Re: Application by Urban Era Builders & Developers Ltd. for Rezoning at
4600 Steveston Highway from Single-Family Housing District, Subdivision
Area E (R1/E) to Single-Family Housing District, Subdivision Area K (R1/K)

Date: April 29, 2008

File: 12-8060-20-8371
RZ 07-372498

**Development Application
 Data Sheet**

TREE SURVEY AND PROPOSED SUBDIVISION PLAN OF
LOT 411 SECTION 2 BLOCK 3 NORTH
RANGE 7 WEST NEW WESTMINSTER DISTRICT PLAN 49421

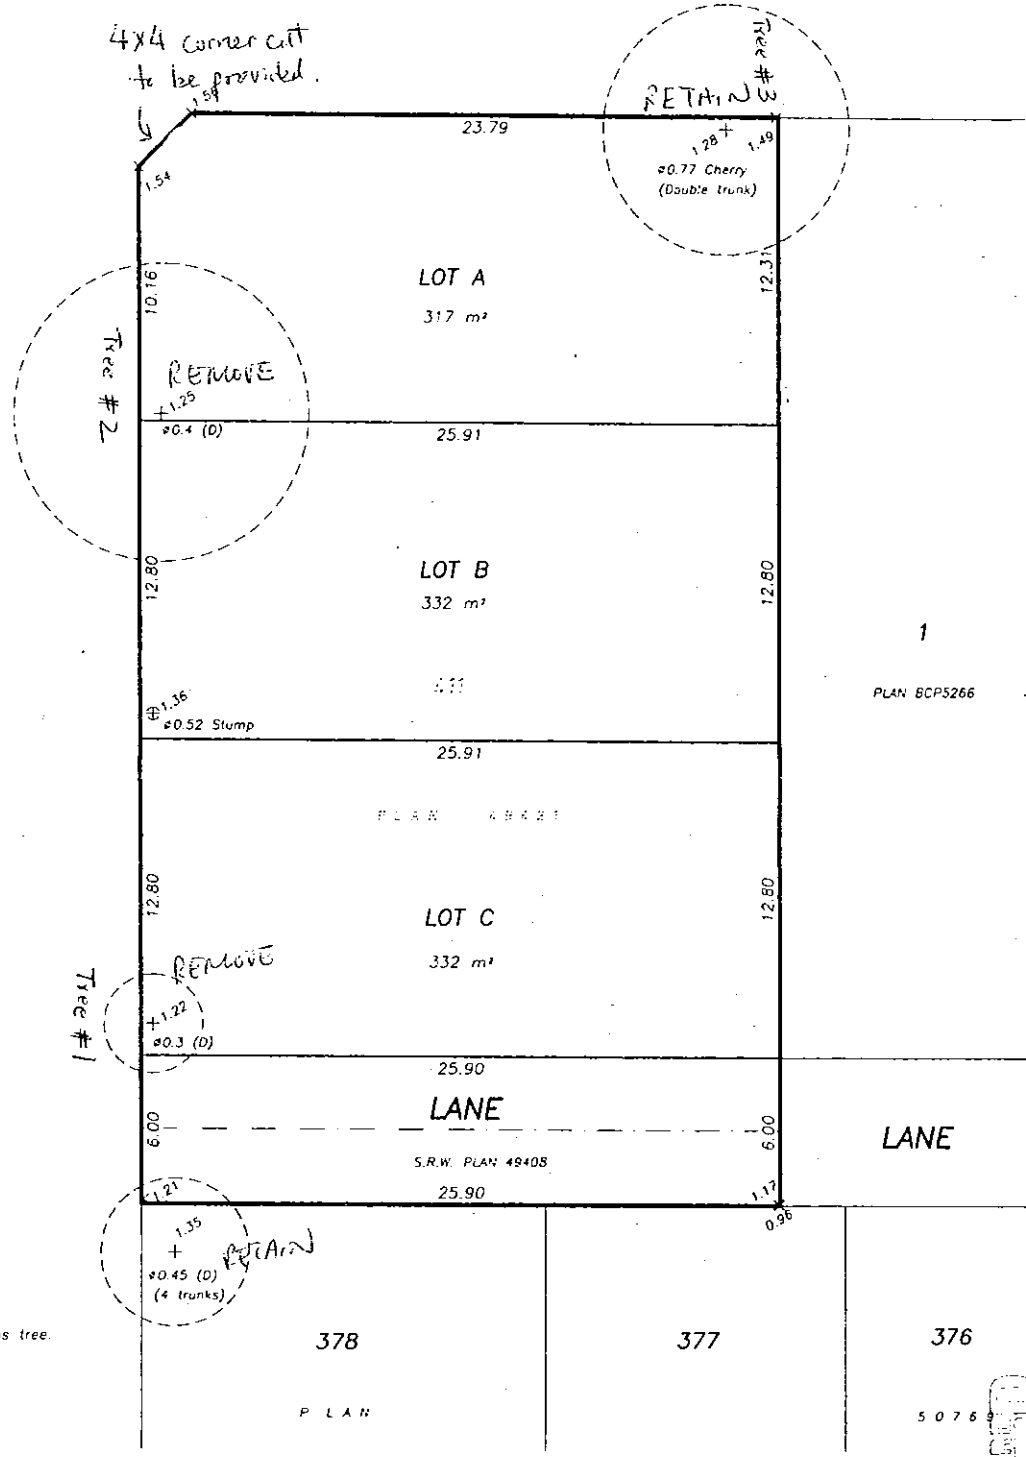
A Tree Survey (**Attachment 3**) submitted by the applicant indicates the location of four (4) trees:

- three (3) bylaw-sized trees on the subject property; and
- one (1) bylaw-sized trees on the adjacent property to the south (11080 Trimaran Gate).

A Certified Arborist's report was submitted by the applicant in support of the application. Based on the comments of the Arborist Report, staff support the retention of the Cherry tree along the Steveston Highway frontage and the Dogwood tree located on the adjacent property to the south. Tree protection fencing must be installed prior to final adoption of the zoning bylaw or demolition of the existing dwelling on the subject property, whichever occurs first, and must remain in place until construction of the future dwellings on the site is complete.

Staff support the removal of the Apple tree along the Trimaran Gate frontage on the basis of the tree condition. Based on the 2:1 tree replacement ratio goal stated in the Official Community Plan (OCP) and the size requirements for replacement tree in the Tree Protection Bylaw No. 8057, two (2) replacement trees with a minimum of 11cm calliper sizes are required.

The Arborist report has identified a Walnut tree in good condition which is required to be removed due to a conflict with the proposed shared driveway to the two (2) northern lots. Staff have explored alternate driveway configurations in an effort to retain this tree; however, due to the size and spread of the Walnut's canopy and its multi-branching habit, the shared driveway would have to be relocated to the south edge of the middle lot. This would eliminate any landscaping in the front yard of the middle lot to make room for an access easement for the northern lot, which is not a preferable option. Relocating this tree is also not viable due to existing canopy size. In light of these constraints, the applicant has agreed to provide a new Walnut replacement tree at 8 cm calliper minimum, in addition to the usual 2:1 replacement ratio, to be located on the development site at the corner of Steveston Highway and Trimaran Gate.

1. Installation of appropriate tree protection fencing around the Cherry tree along the Steveston Highway frontage (4 ft. away from the west side of the stem and 6 ft. away from the south side of the stem) and the Dogwood tree located on the adjacent property to the south (along the common property line) on site prior to final adoption of the rezoning bylaw or any construction activities, including building demolition, occurring on-site.

2. Provide proof of contract with a Certified Arborist for supervision of on-site works conducted on the subject property within the drip line of the Cherry tree along the Steveston Highway frontage and the Dogwood tree located on the adjacent property to the south (11080 Trimaran Gate). The contract should include provisions for completion of a post-impact assessment report (if applicable) to be reviewed by the City.

LANDSCAPE PLAN
ITO LANDSCAPE ARCHITECTS
L1 OF 3

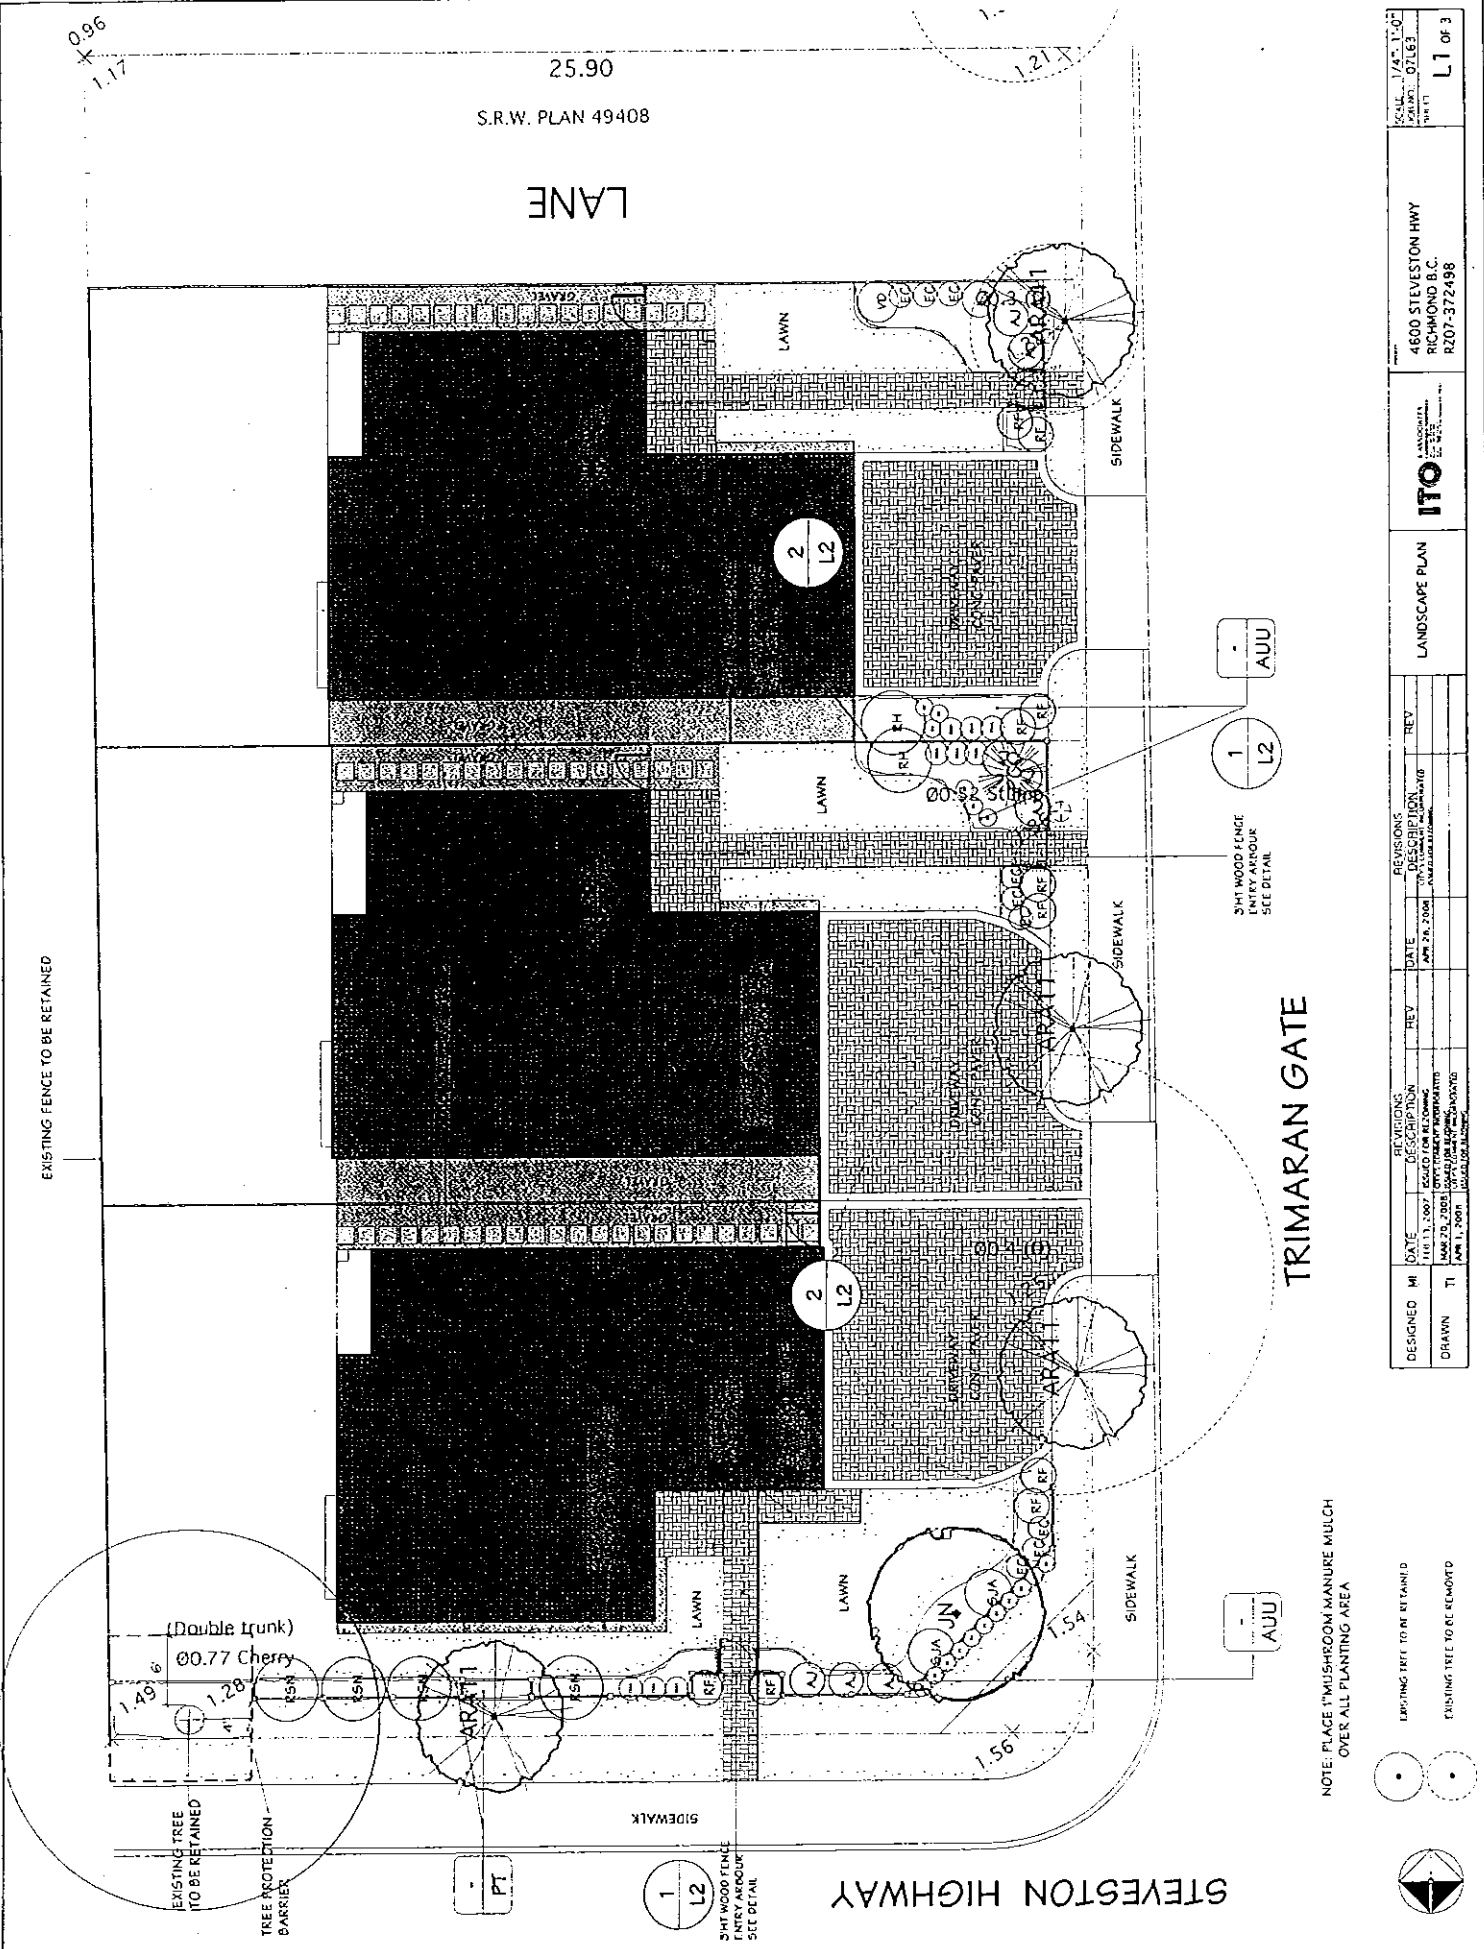
To illustrate how the front yard along Trimaran Gate and flanking side yard along Steveston Highway of the future corner lot will be treated, the applicant has submitted a Landscape Plan (**Attachment 4**) prepared by a registered landscape architect for the future lots in support of the application. The Landscape Plan indicates the front yard and flanking side yard will be landscaped with a mixture of small trees, shrubs and ground cover, and is considered in compliance with the guidelines of the Official Community Plan's Arterial Road Redevelopment Policy. Four (4) replacement trees at 11 cm calliper, one (1) Walnut tree at 8 cm calliper, and one (1) coniferous tree are included in the Landscape Plan. The applicant has also agreed to maintain a minimum 1.0 wide landscape strip along the Trimaran Gate frontage of the two (2) northern lots, except at the driveway crossing to screen the expansive pavement in the front yards of the two (2) future lots. In order to ensure that this work is undertaken, the applicant has

agreed to provide a landscape security in the amount of \$8,228.40 prior to final adoption of the rezoning bylaw.

3. Submission of a Landscaping Security to the City of Richmond in the amount of \$8,228.40 for the landscape works as per the landscape plan attached to the report (Attachment 4).

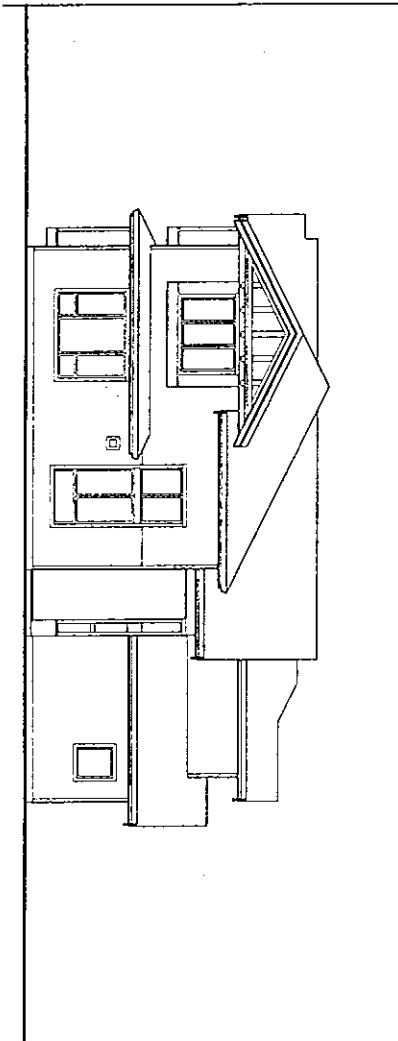
To illustrate how the future corner lot interface will be treated, the applicant has submitted a set of preliminary Building Elevations (**Attachment 5**). The plans indicate that the main entrance to the future dwelling on the corner lot is from Trimaran Gate. At future development stage, Building Permit plans must be in compliance with zoning.
